ADDENDUM NO. 1

Date: 7/11/2017

Project: Field Improvements at West Campus High School

West Campus High School
Synthetic Practice Field & Road Improvements, Inc. 1

FIELD EQUIPMENT
DETAILS

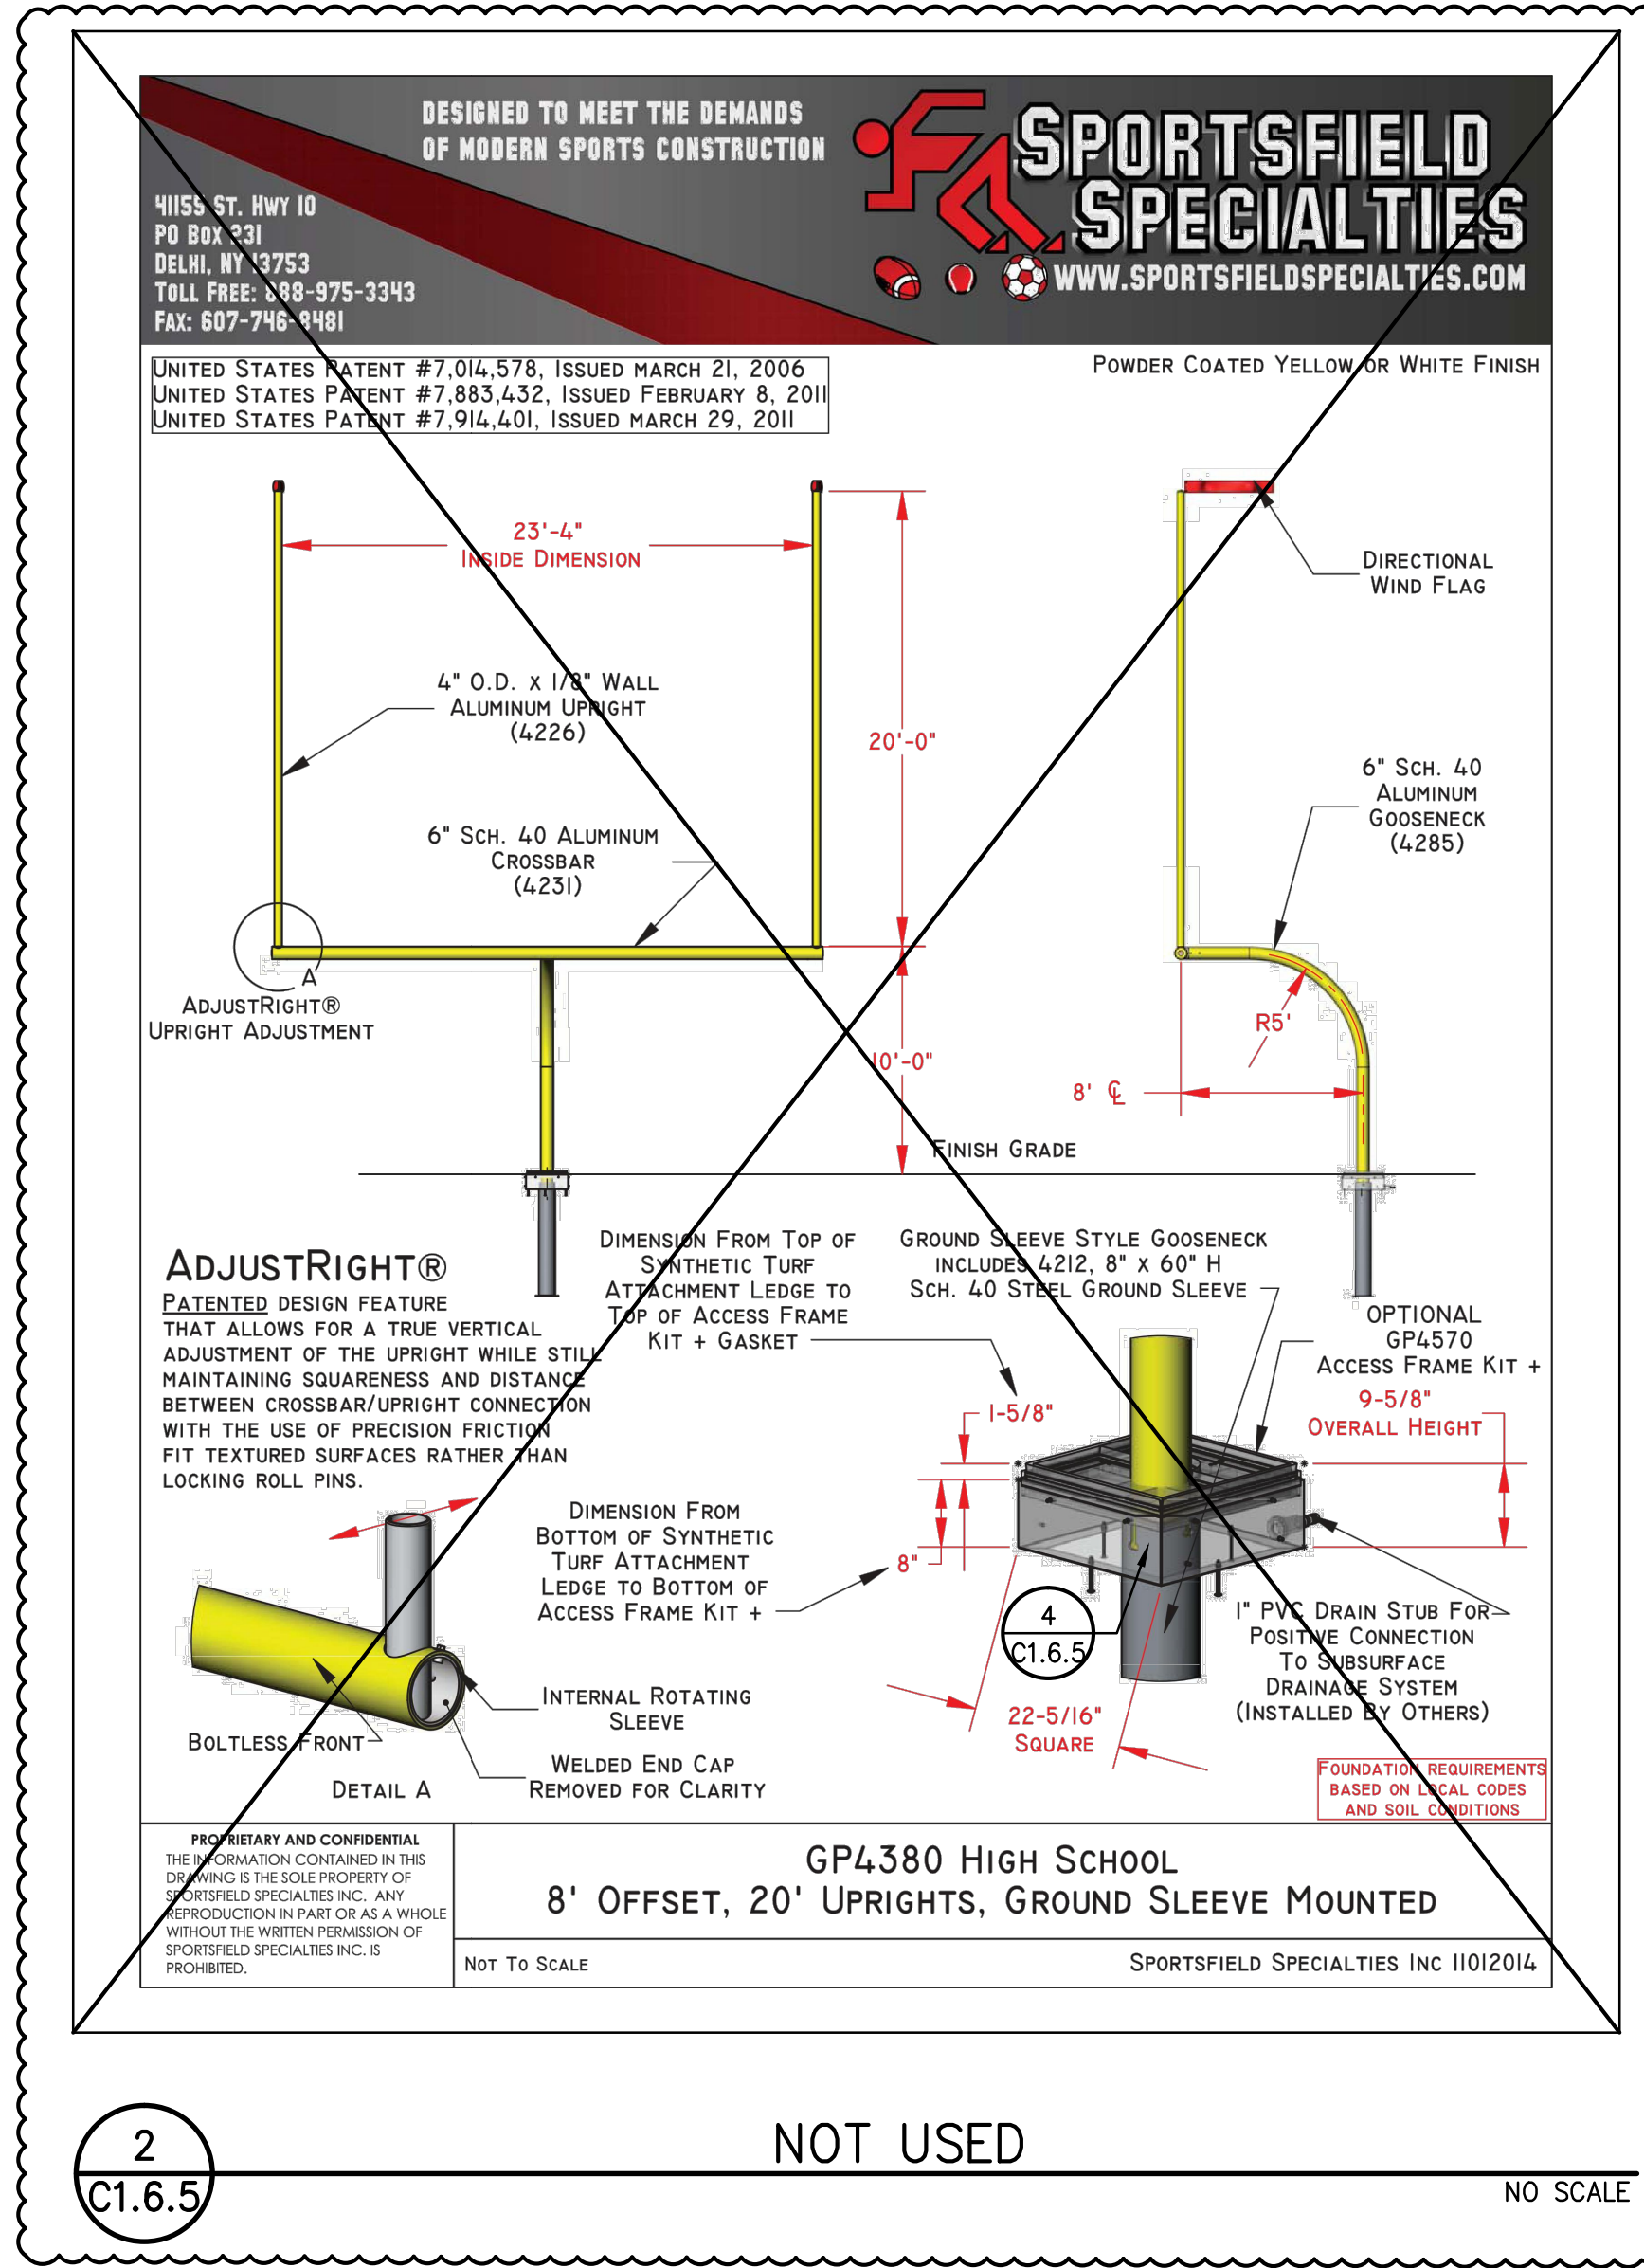
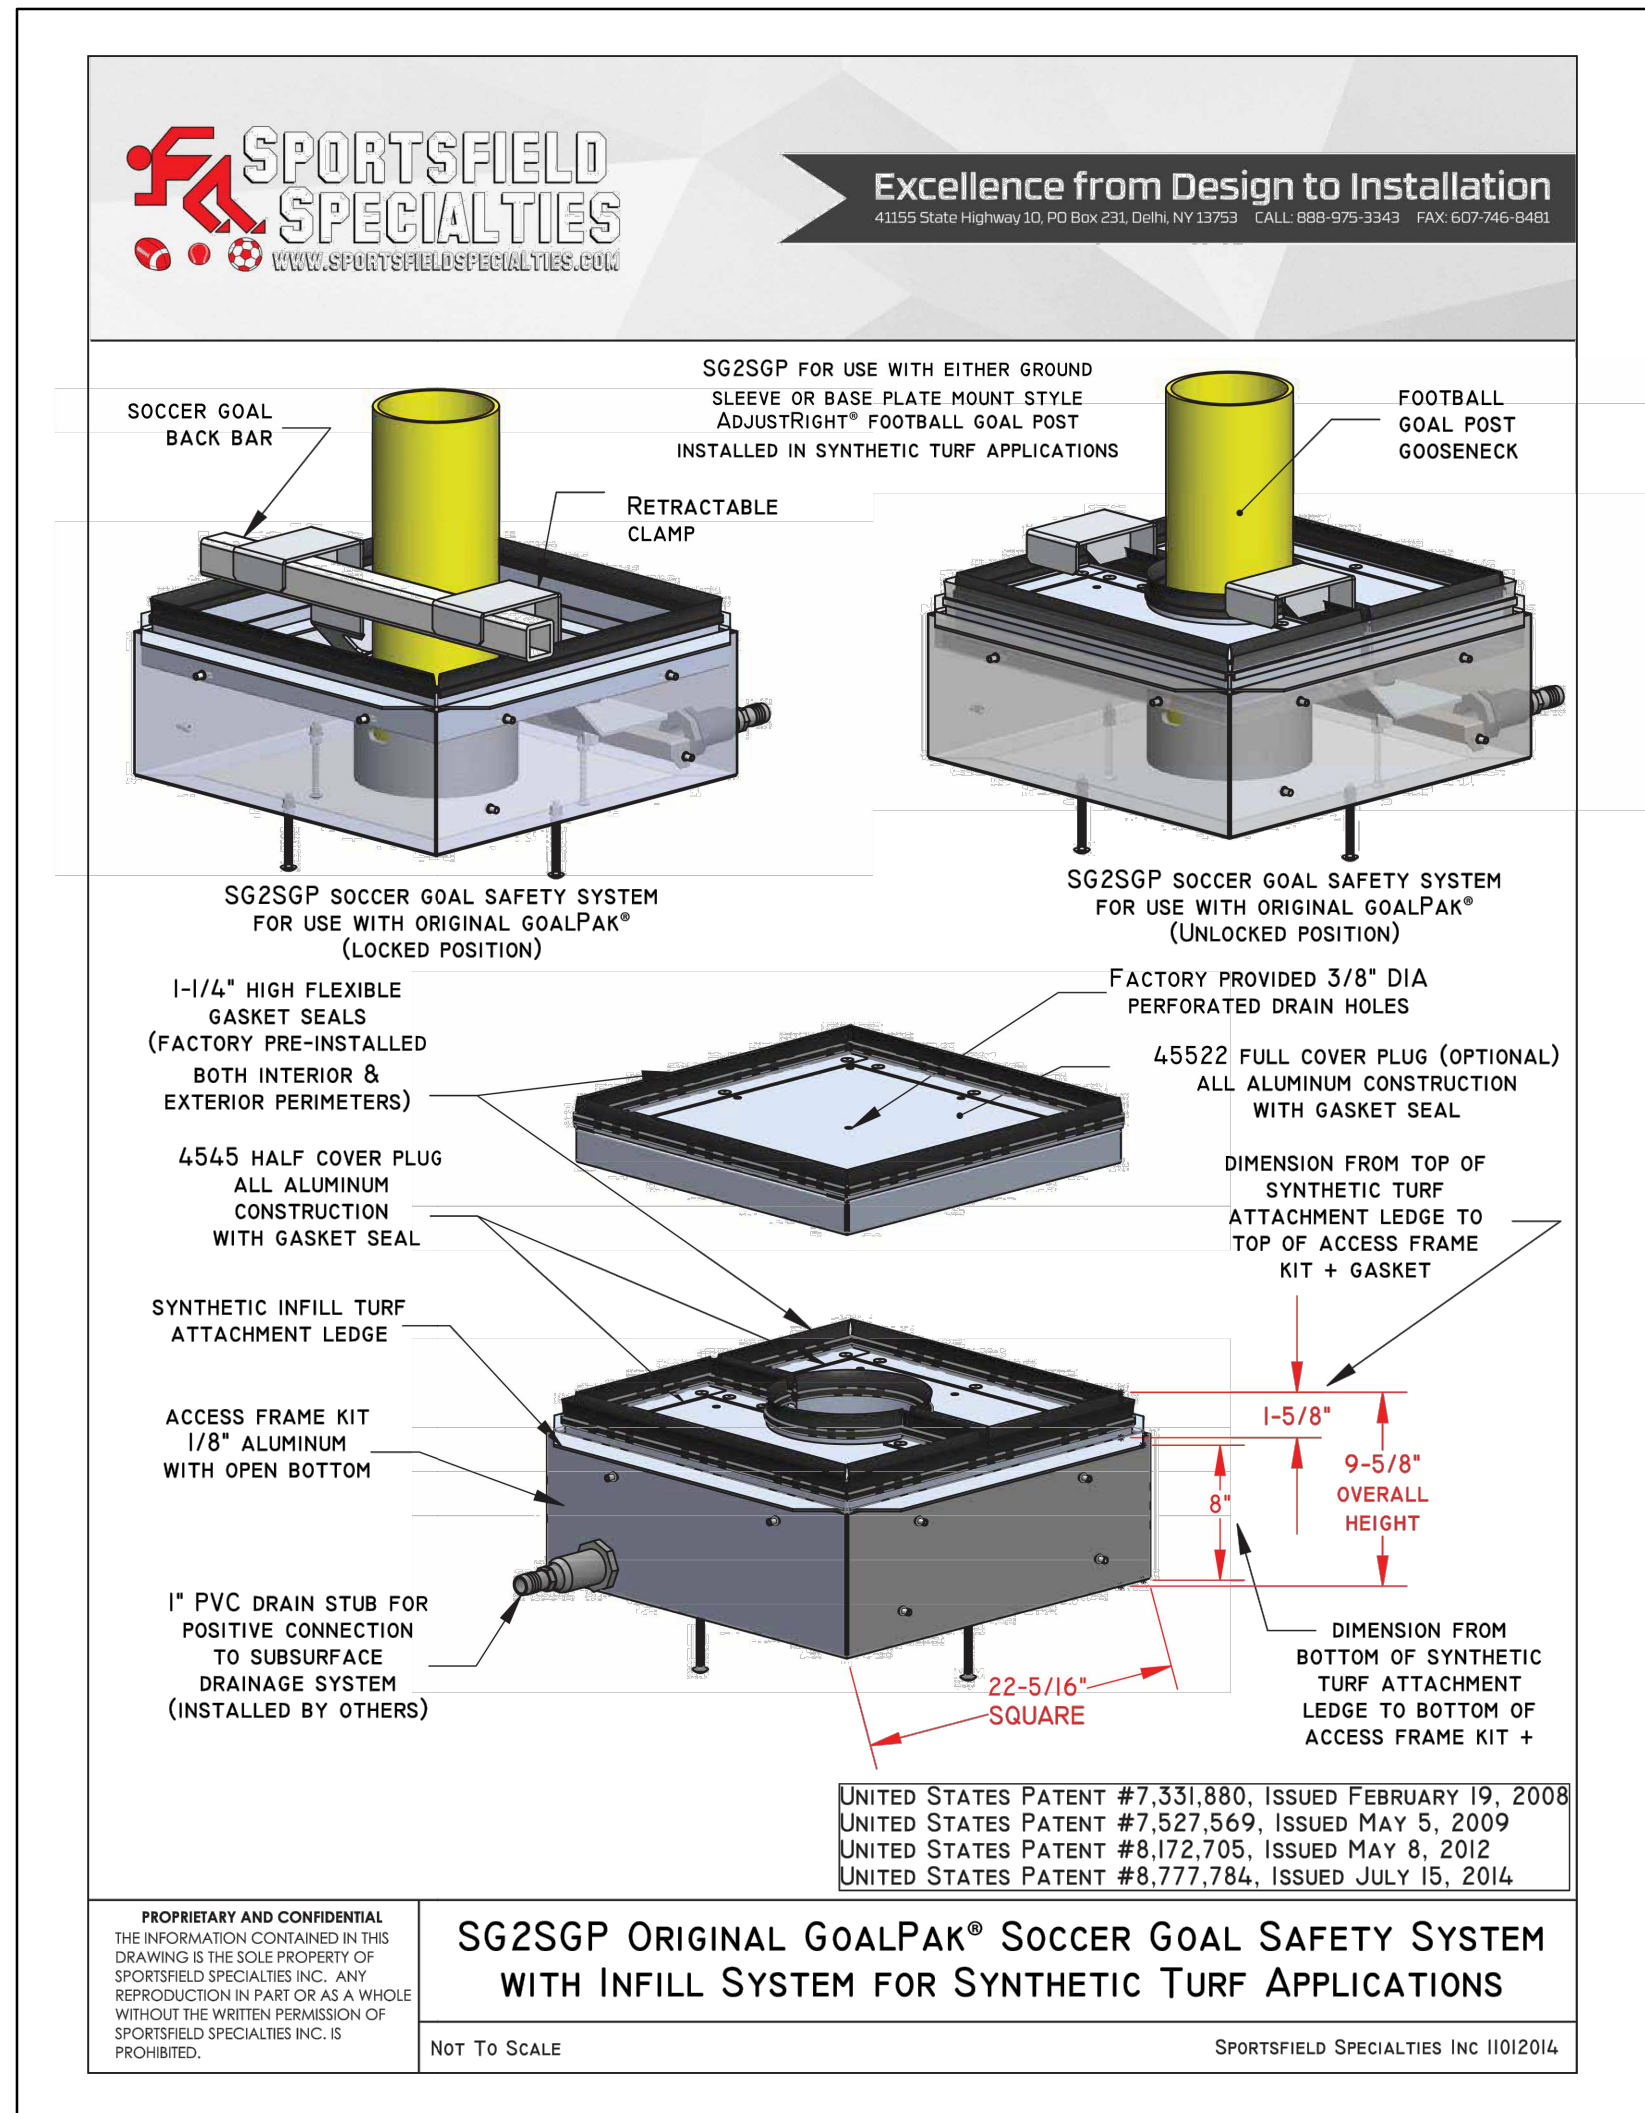
7. AD1-7 FIELD LAYOUT PLAN
 - a. Ground sleeves and soccer lock down to be installed at both goal ends.
8. AD1-8 FIELD FENCING AND EQUIPMENT PLAN
 - b. Only goal sleeves to be installed, goal posts to be provided but not installed.
9. AD1-9 FIELD FENCING SECTIONS AND DETAILS
 - c. Goal post to be provided but not installed.
10. C1.6.5 FIELD EQUIPMENT DETAILS
 - d. Some equipment not used.
11. C1.8.3 DETAILS AND SECTIONS
 - e. Field section detail updated.
